ADDENDUM #1

SPANGS Building P-1 Interior Repair - BGS Project # 3700

South Portland Air National Guard Station, 50 Western Ave, South Portland, ME 04601

28 August 2023

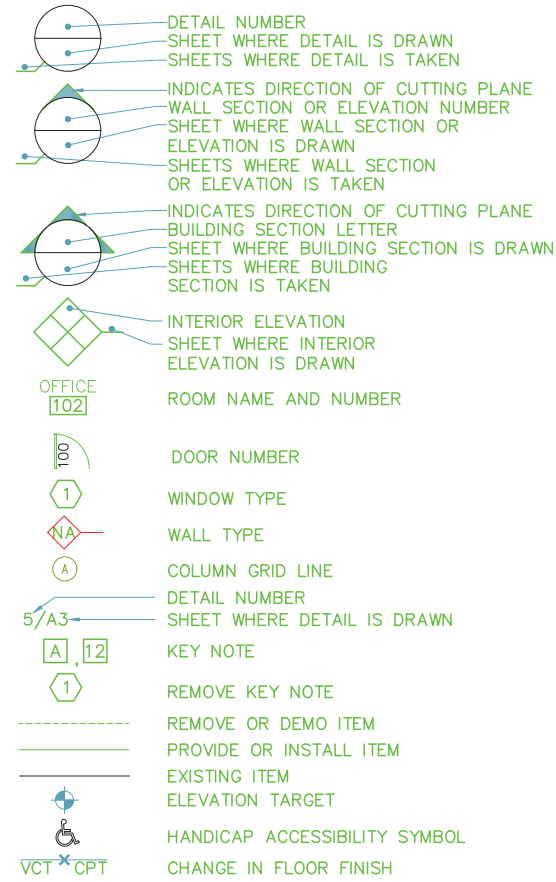
3.2.2. **Office Modifications (Room 1):** Perform modifications to Room 1 to create Room 1A, Room 1B, and Room 1C. Work includes walls, lighting, electrical, fire alarms, and HVAC. See Figure 1 for concept.

3.2.3. **Office Modifications (Room 45):** Perform modifications to Room 45 to create Room 45A and Room 45B. Work includes walls, lighting, electrical, fire alarms, and HVAC. See Figure 1 for concept.

G-002

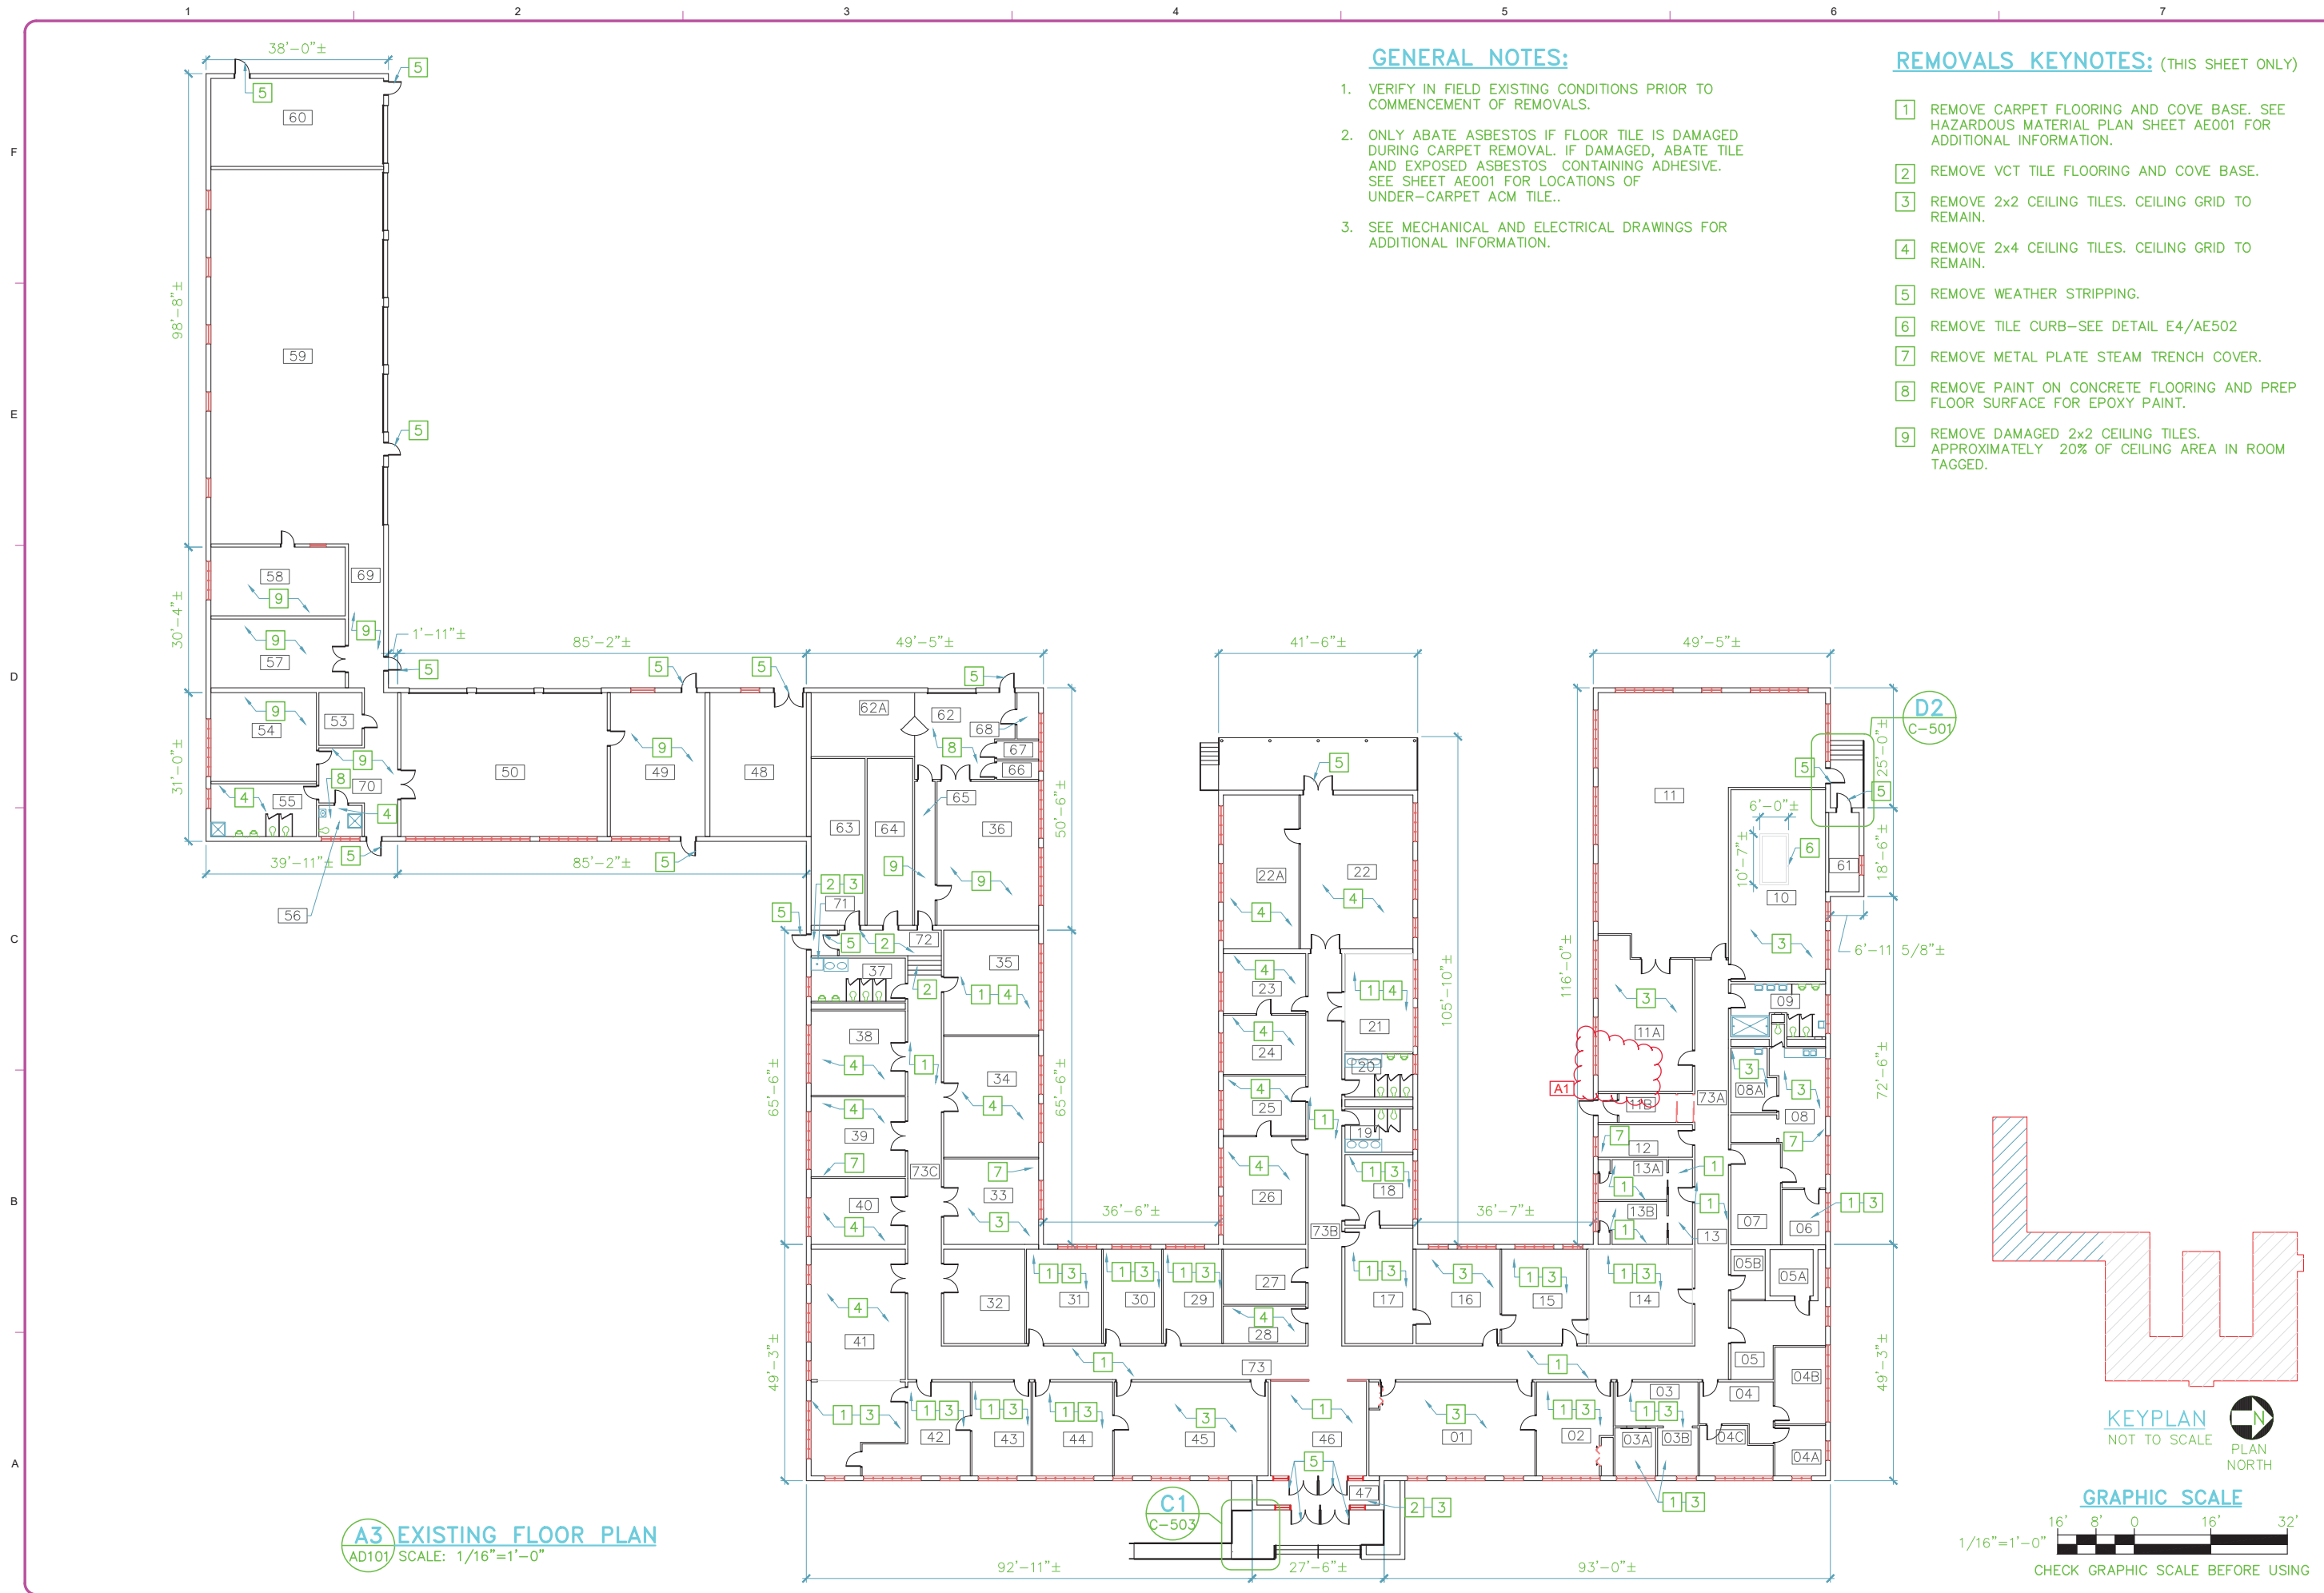
1. Is there an allowance for the ACM abatement work?
 - a. No. See 01 10 00 and Drawings G002 and AE001 for the ACM Abatement included in the base bid.
 - i. Drawings G002 - UNIT PRICE AND QUANTITY SCHEDULE - ITEM 1 has been updated.
 - ii. Drawing AE001-
 1. ABATEMENT SCOPE OF WORK has been modified.
 2. The color and pattern of the hatching has been modified for clarity.
 - iii. Section 01 10 00 - Summary of Work, Paragraph 3.1.2 has been modified to include the Asbestos Abatement Base Bid SF amount.

UNIT PRICE AND QUANTITY SCHEDULE				
ITEM	DESCRIPTION	UNIT	BASE BID QUANTITY	UNIT PRICE REQUIRED
1	REMOVAL OF ASBESTOS CONTAINING FLOOR TILE AND ADHESIVE	SF	926	YES
				A1
